Clump Point and Dunk Island Jetties

Executive Summary:

CivilPlus Constructions Pty Ltd (CivilPlus) has been awarded the contract for reconstruction of Clump Point and Dunk Island jetties based on their preliminary design. At the time of award, the geotechnical investigation had not been completed, but historical geotechnical information including boreholes and pile driving records for the previous (1961) Clump Point jetty were available and used for preliminary determination of pile lengths

Approved:		
Job Number:	Drawing No.	Revision
T12-058	ST1.01	G

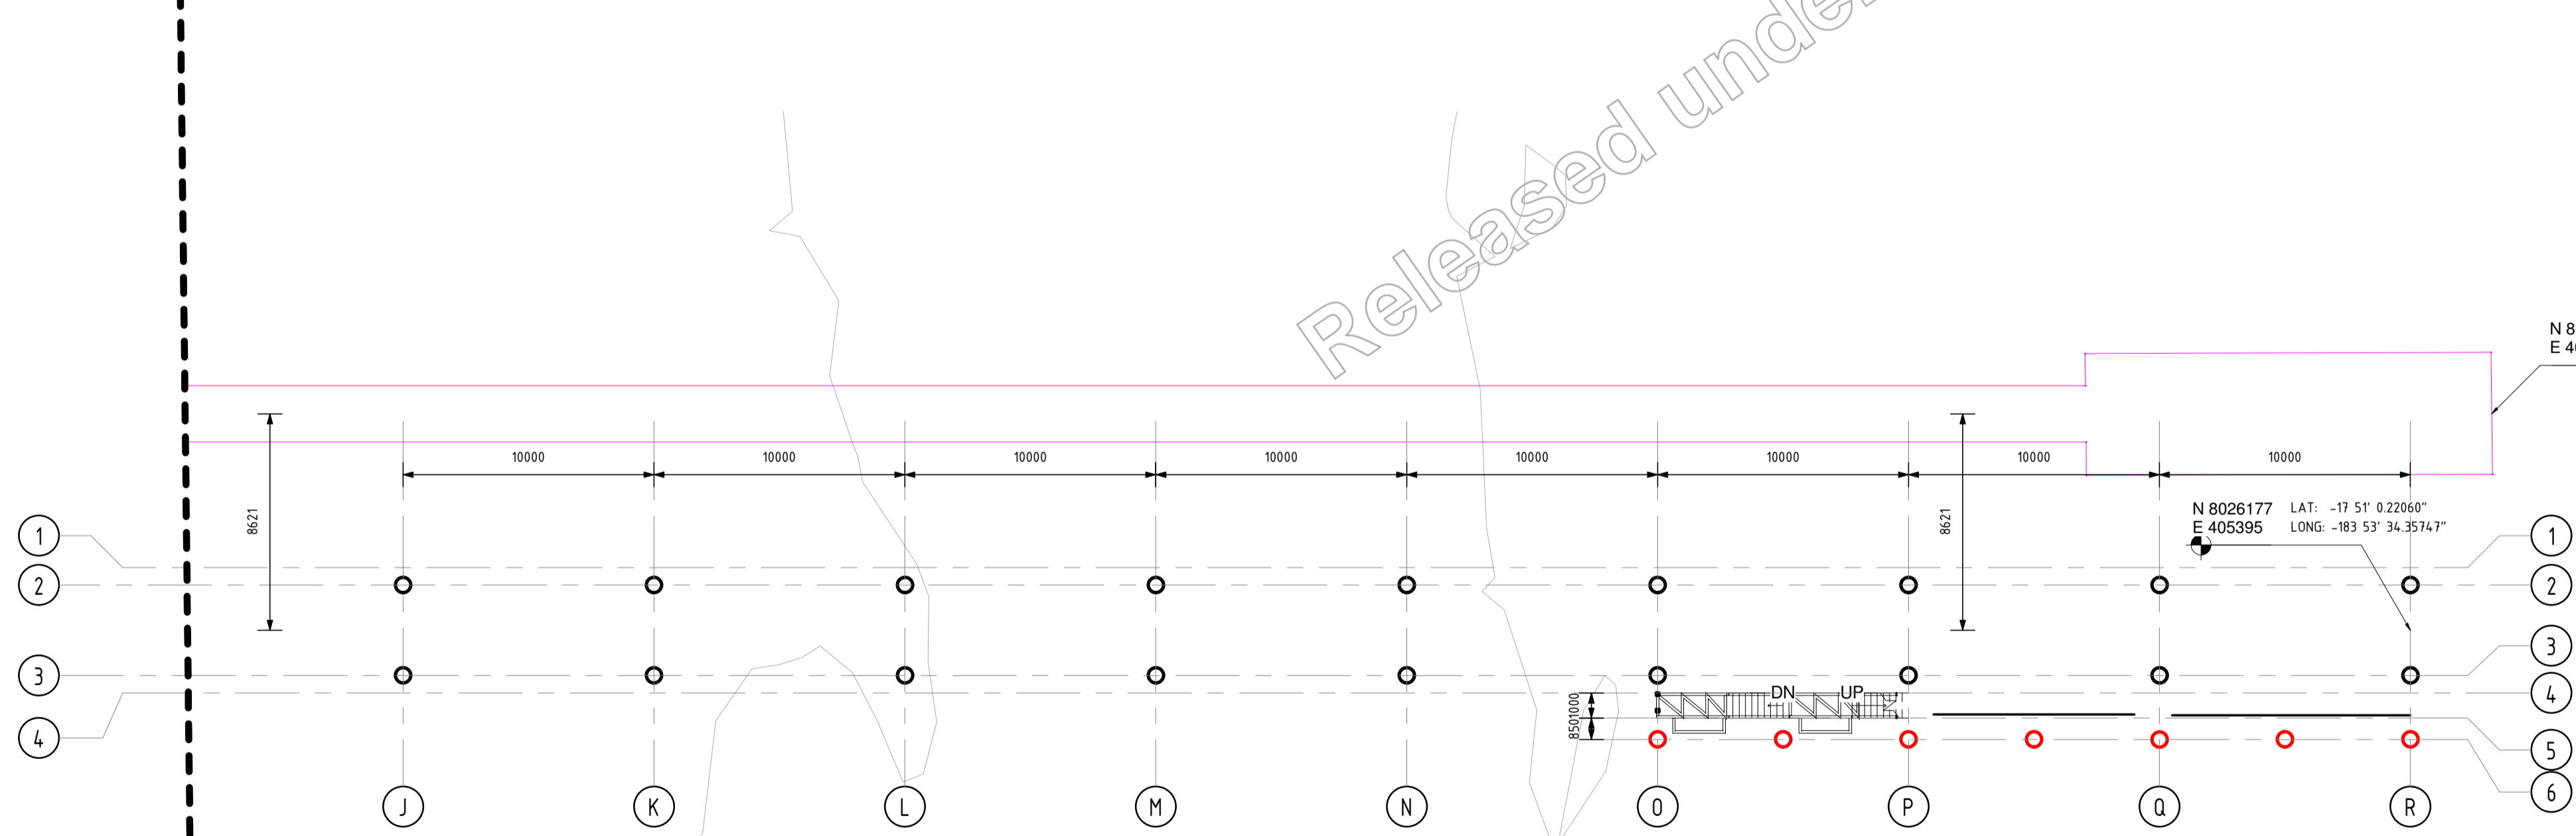
1. Reissue as "For Approval"
2. Update the details in the title block
3. Have drawings signed by the RPEQ
4. Notes to Sheet ST1.01 might be better elsewhere (ST2.02) - see also modifications
5. Review drawing titles and make consistent with Sheet list
6. Modify drawings to locate fender piles closer to jetty deck (see comments on attached drawings)
- 7.

Job Number	Drawing No.	Revision
T12-058	ST2.04	E

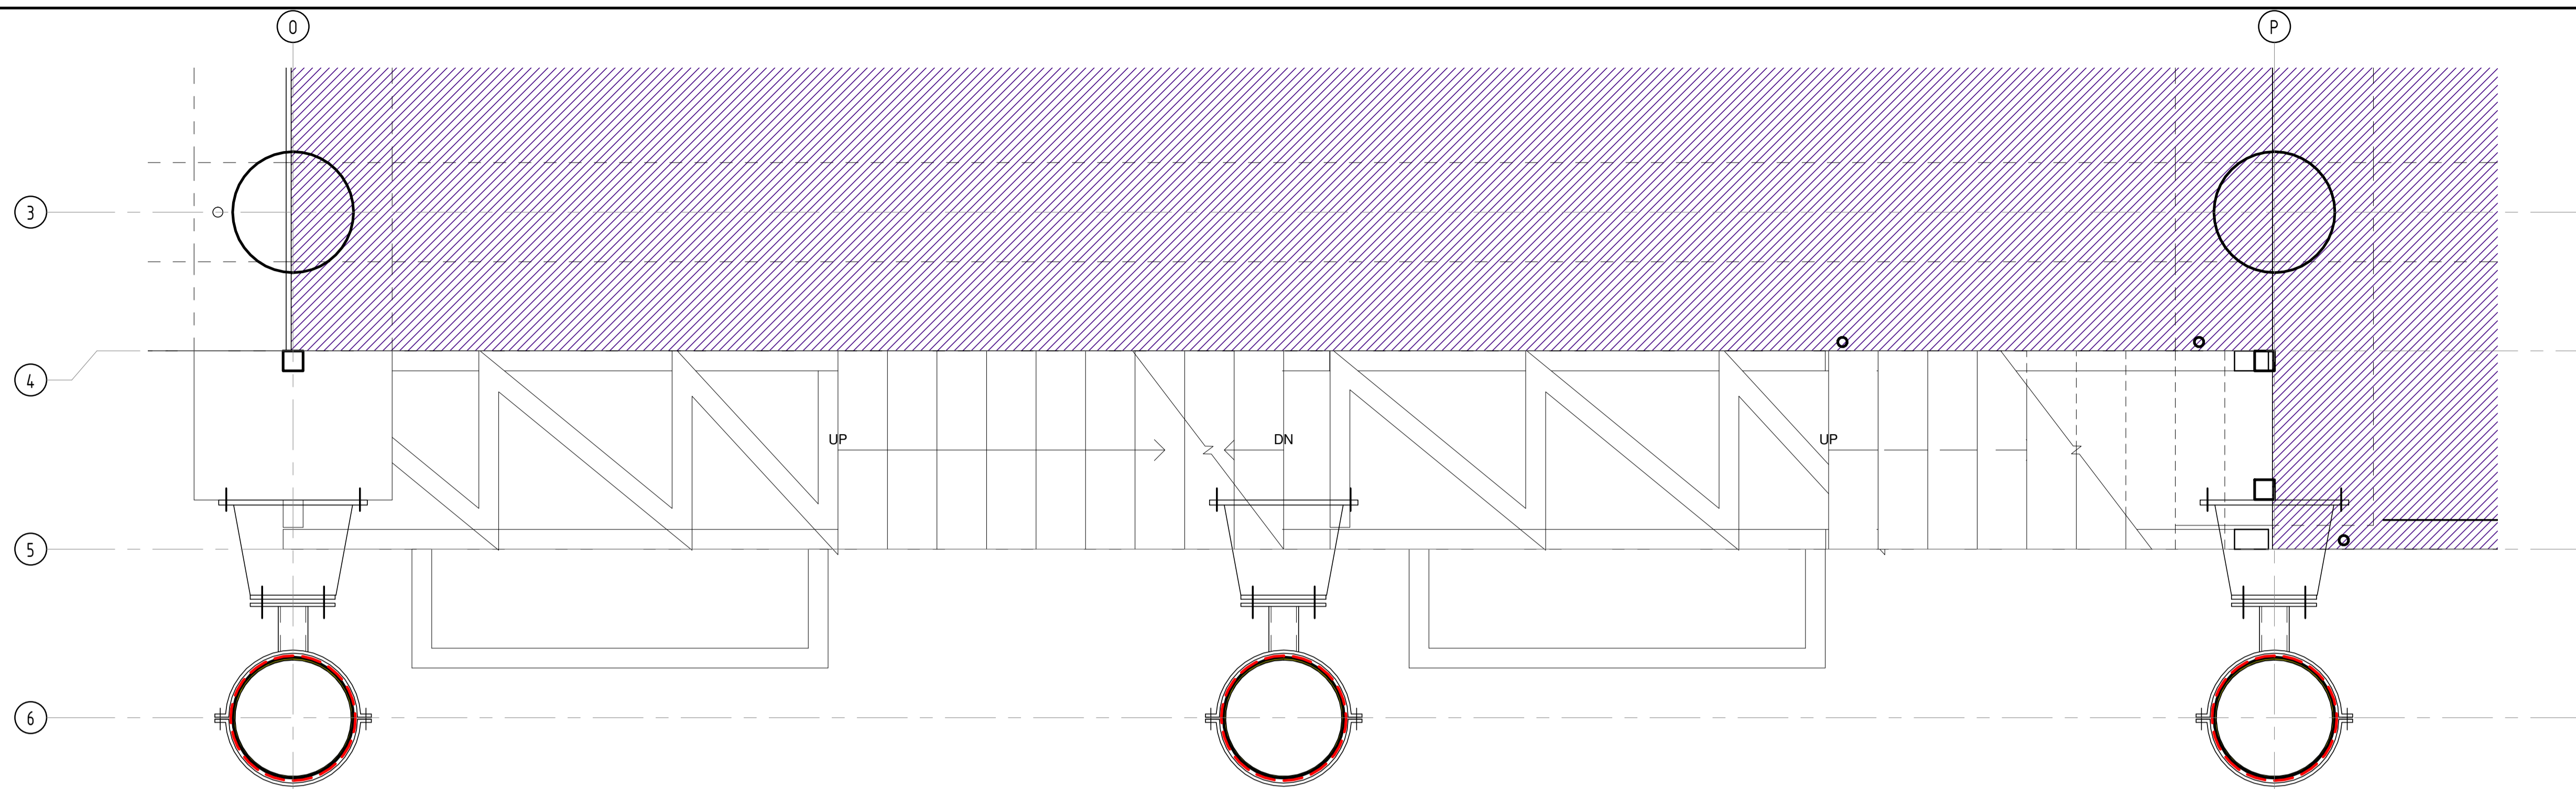
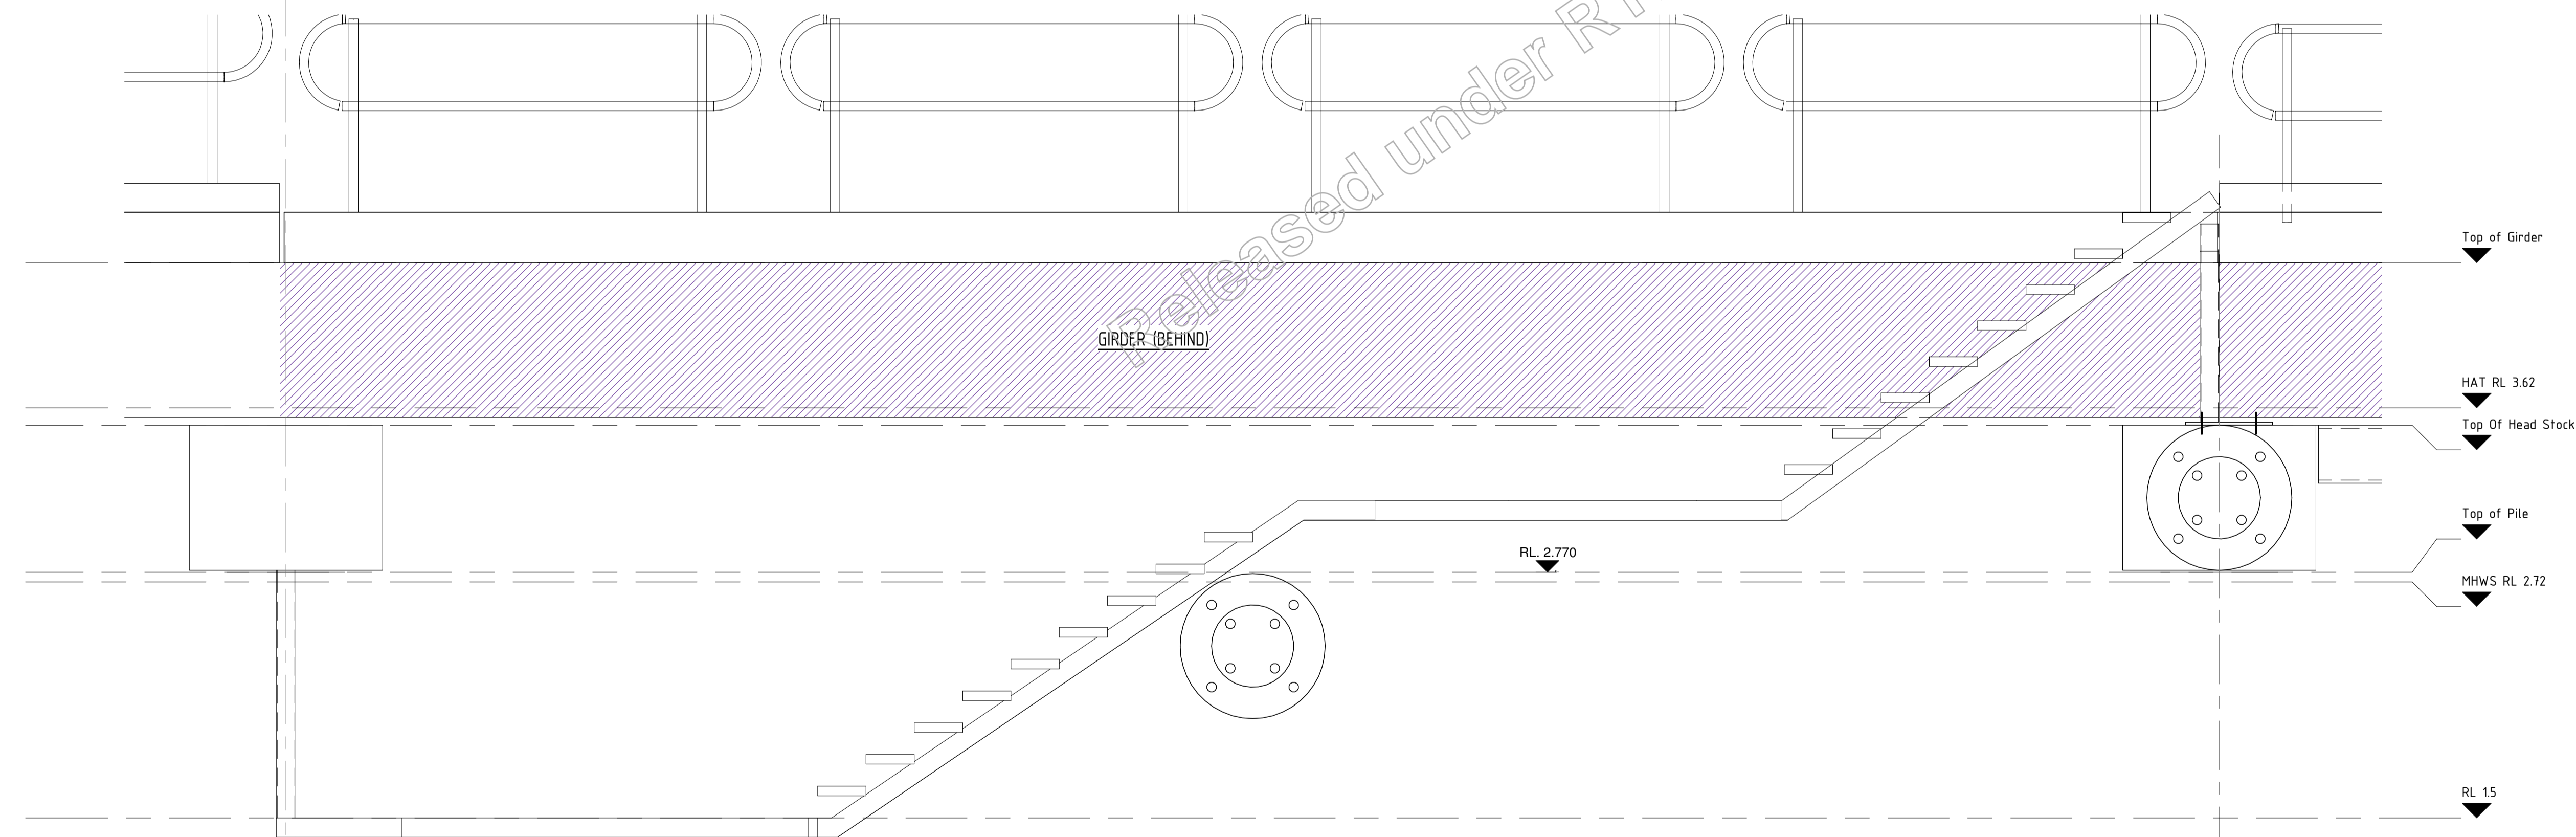
1. Show RL on contour lines and make light contour lines more visible (ie darker)
2. Show vertical datum as LAT, either by note or in title block
3. Lift lower landing higher and show landing/stairs to clear the middle fender cone
